SHOP DRAWING REVIEW

Millwork Shop Drawing
Meridian Place

Job # 534 By: Bryan Bonell Date: Sept. 13, 2019

HOBIN ARCHITECTURE INCORPORATED

Kitchen Plan View

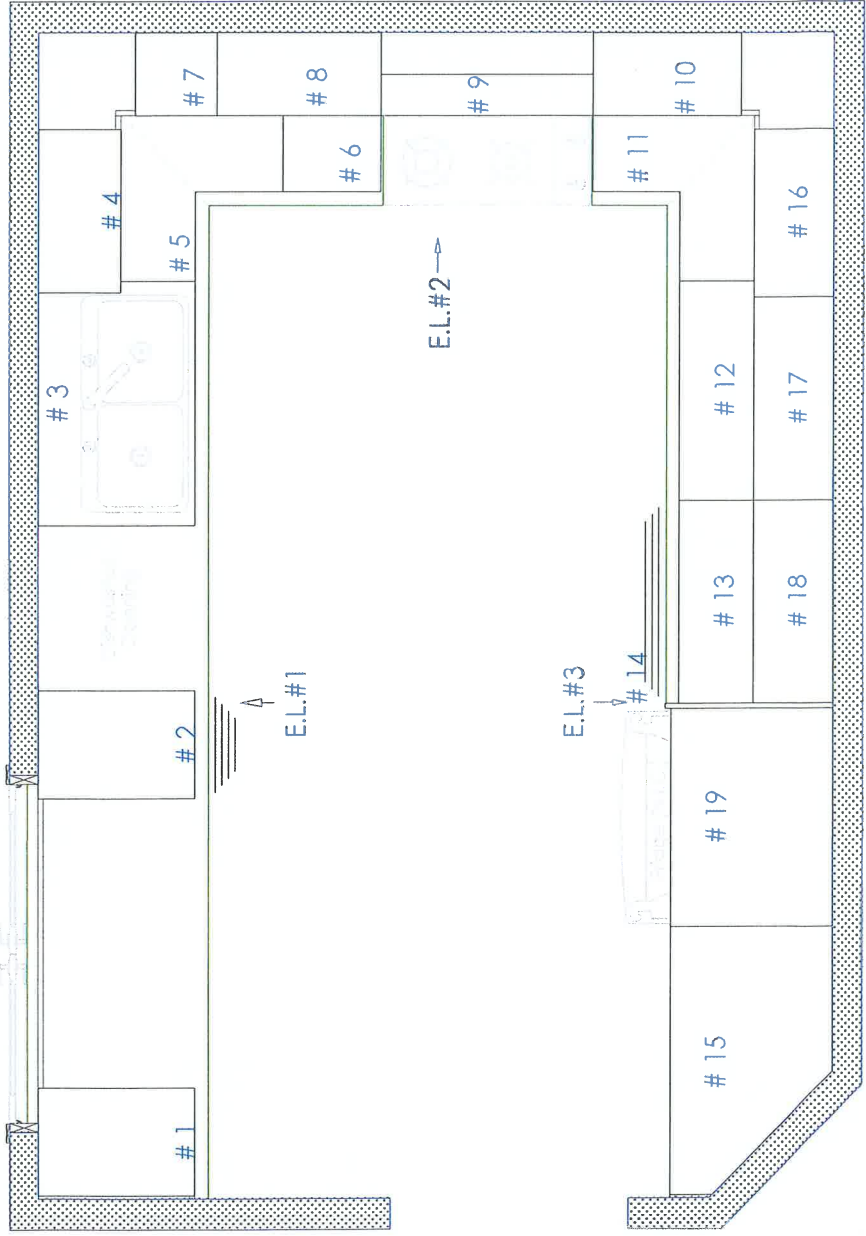
SITE CONFIRM OVERHUNG ROOM DIMENSIONS.

* NOTE: ADJUST DEPTH OF BULKHEADS OVER CABINETS TO 630mm TO ACCOMMODATE 635mm DEEP CABINETS.

Kitchen Elevation #2

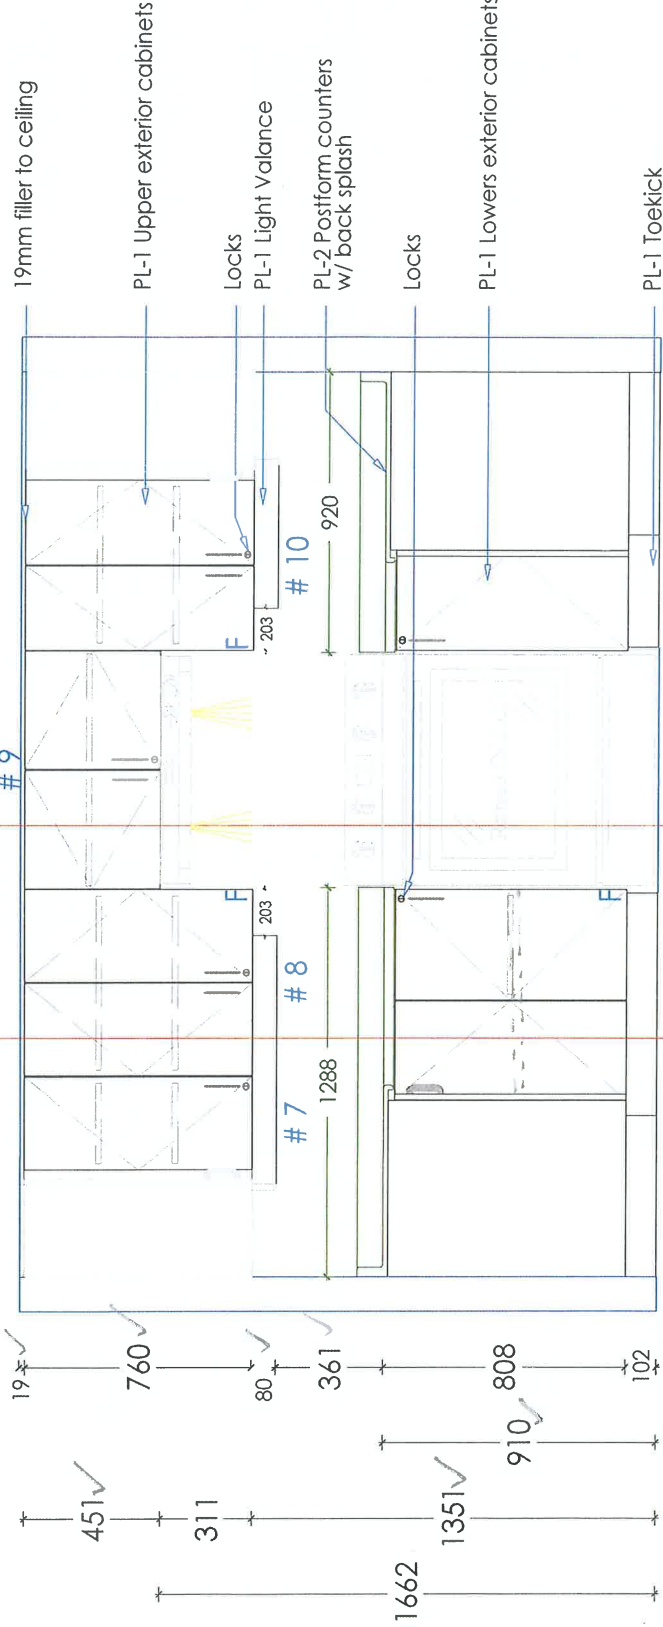
Robin to confirm dimension for Stove Range-

Cabinet # 19 Interior

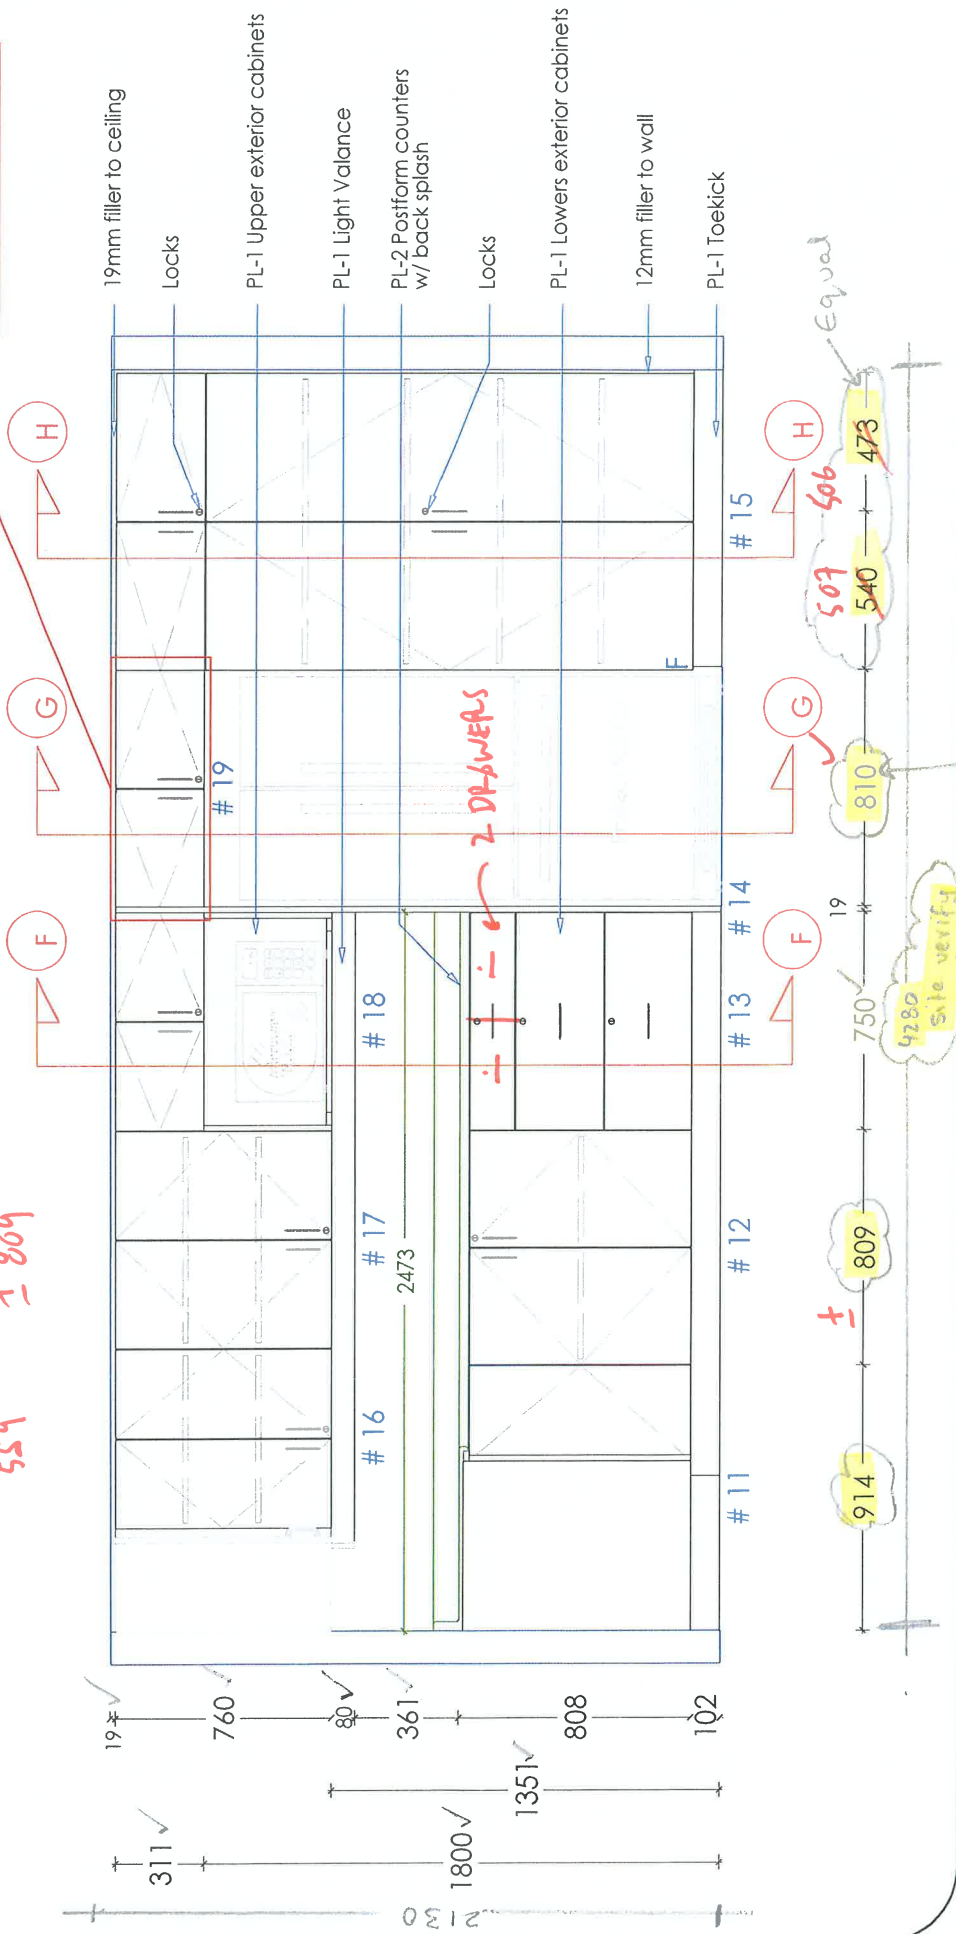
Hobin to confirm Refrigerator Dimension

Laundry Elevation

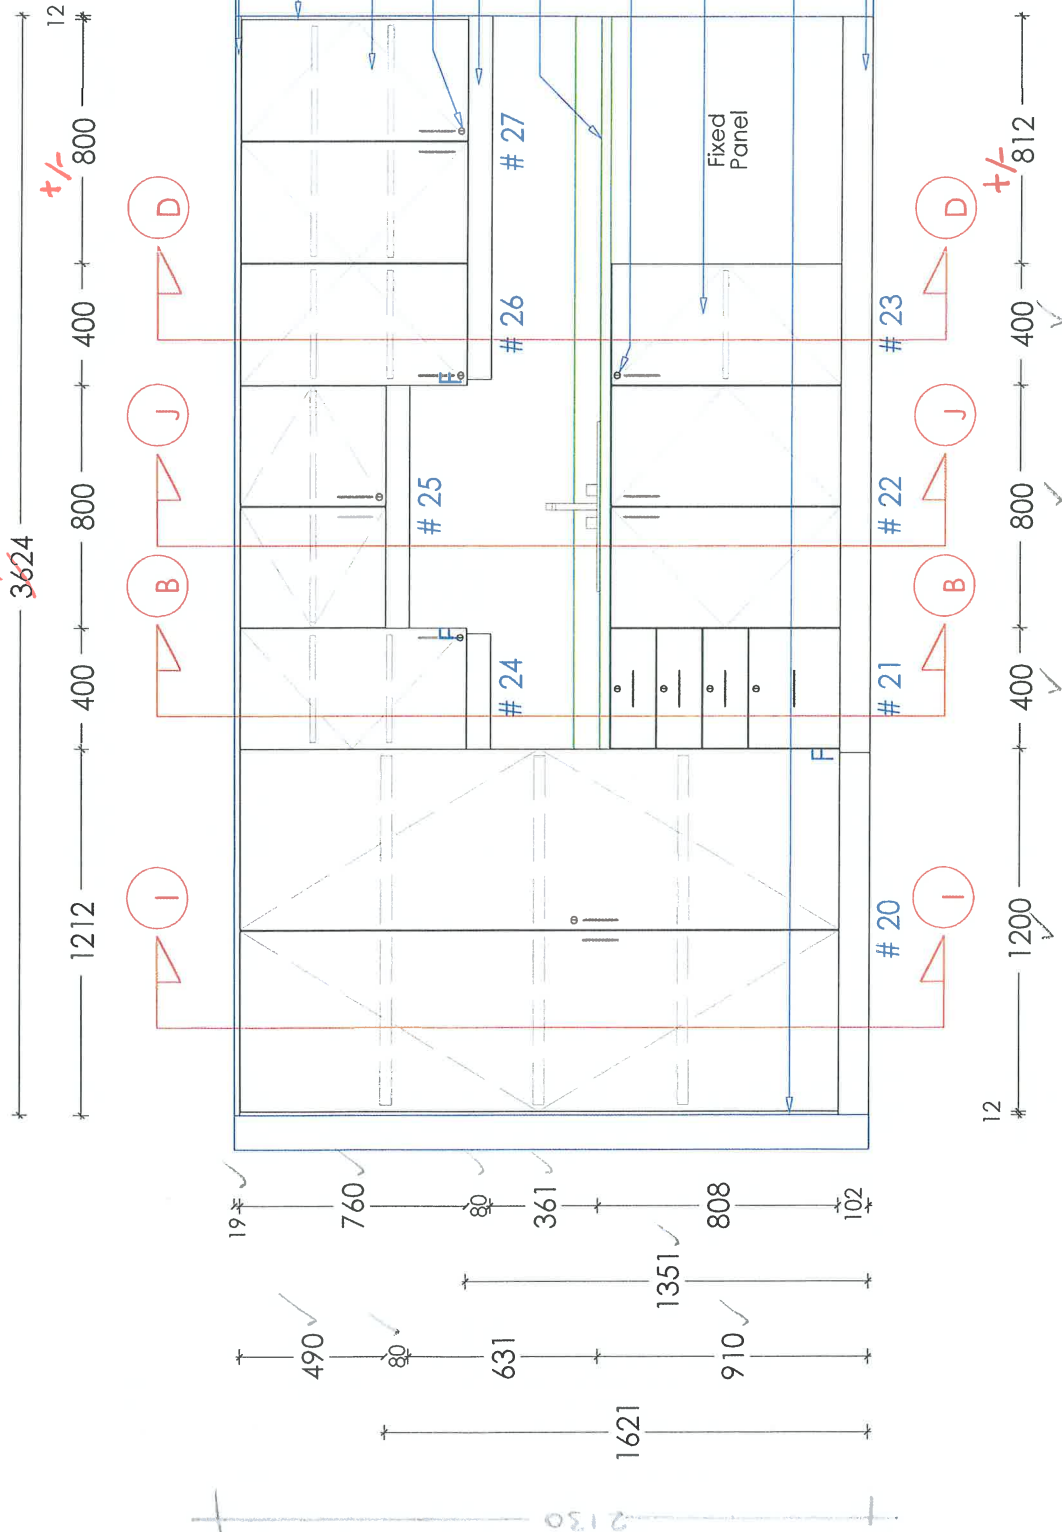
* NOTE: ADJUST DEPTH OF BULKHEADS TO 650mm DEEP TO ACCOMMODATE 635mm DEEP CABINETS.
